AM1705 ARM Microprocessor Silicon Revisions 3.0, 2.1, and 2.0

Silicon Errata

Literature Number: SPRZ311E
March 2010–Revised June 2014

Figure 1. External 3.3V Clock Source

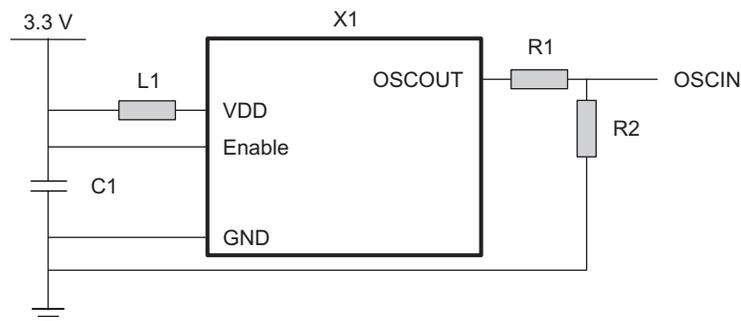
On all silicon revisions, certain design elements make this device susceptible to radiated noise during an ESD strike, as described in the standard IEC 61000-4-2. Exposure to the electrical noise caused by the ESD can cause soft device failures due to noise coupling on the system clock (OSCIN). ESD events within the IEC spec range do not cause permanent device damage and full functionality is recoverable with a device reset. The sensitivity to this noise issue is primarily due to the 1.2V oscillator/clock input implemented on this device. The low voltage range, coupled with slow rise and fall times, provides a lower noise margin than other TI devices with higher voltage internal oscillators (for example, 1.8V or 3.3V oscillators).

If ESD robustness is a concern, it is strongly recommended to avoid using the internal oscillator as a clock source. An external 3.3V clock source with a resistor voltage divider as in [Figure 1](#) can be used to externally generate the required 1.2V input clock. By using an external clock input with fast rise/fall times (less than 5 ns), the noise margin improves significantly, increasing ESD noise resistance.

Legend: L1 = ferrite bead; C1 = 0.1 uF; R1 = 165 ohm / 5%; R2 = 100 ohm / 5%

In addition to using an external clock source, several other board and software recommendations specific to this device can improve system-level ESD immunity:

- The OSCIN and OSCVSS (and OSCOUT, if used) should be routed as short as possible to reduce their ability to pick up EMI noise.
- Route the OSCIN signal on inner board layers where it is shield by power and ground planes.
- The processor should be provided as much power supply decoupling as is practical and placed as close to the processor as possible.
- Implement the PLL filtering circuits shown in the device datasheet.
